DRAWING NO.: GEN-SFD011
FACILITY ID: Y02, M04, M05
SHEET No.: 431
REV: B

MAINTENANCE OF WAY BUILDING
FOUNDATION PLAN - OVERALL

MAINTENANCE OF WAY BUILDING
FOUNDATION PLAN - AREA A

TOP OF WALL ANCHORAGE AT PERPENDICULAR JOISTS - CONCENTRATED LOADS DETAIL
SCALE: 1" = 1'-0"
M04-SFP116
M04-SFP117

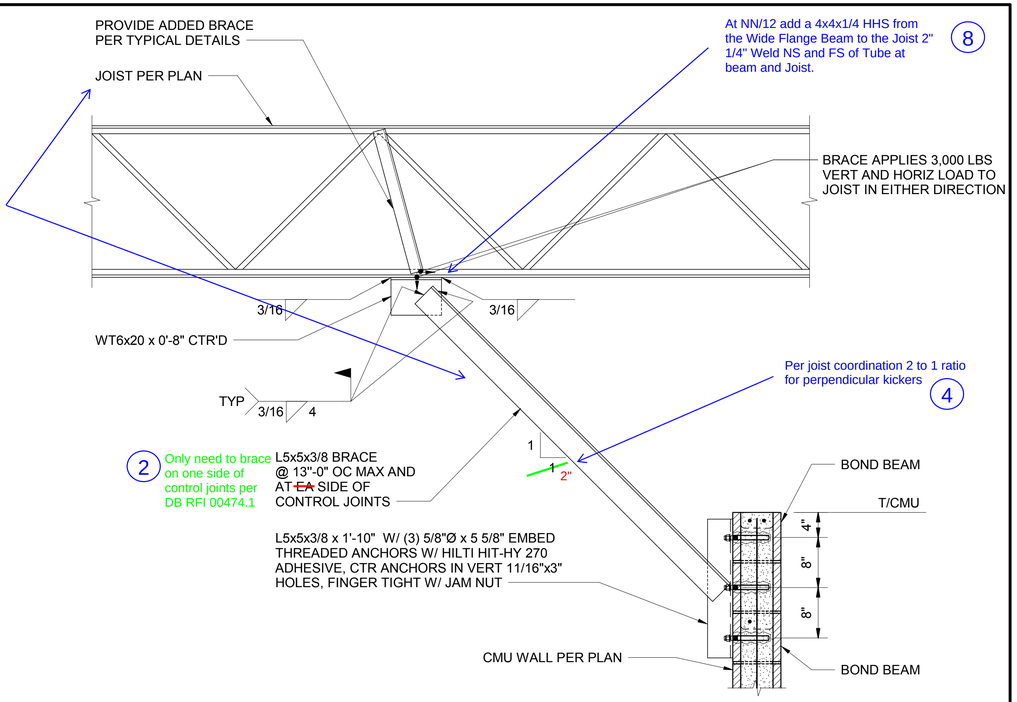
8 Where Kicker Braces land on a W shape beam in lieu of a joist, it is acceptable to use a one to one slope

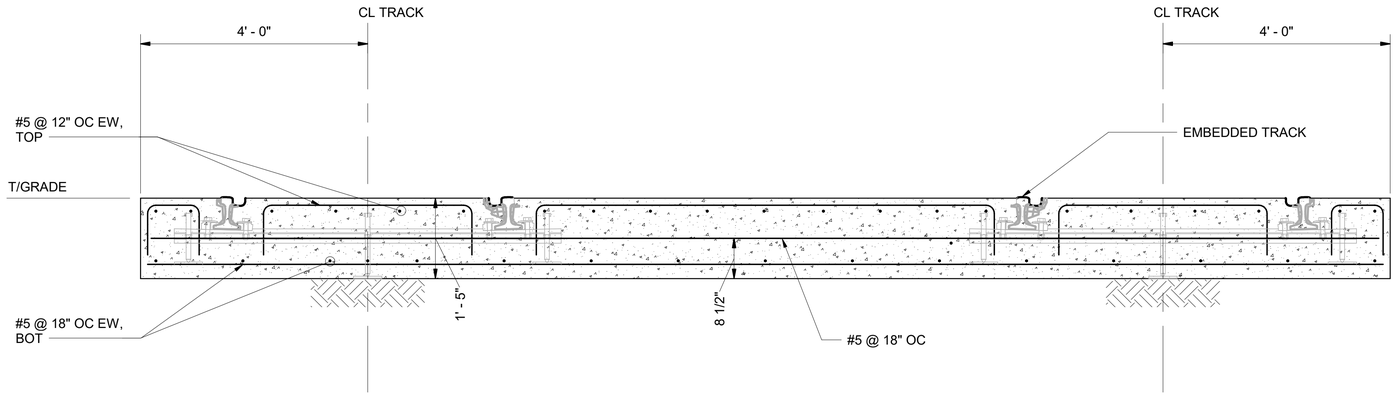
1 Add 8" concrete furred out wall. See DB RFI 00194.1 for detailed dimensions, rebar information, and epoxy dowel information
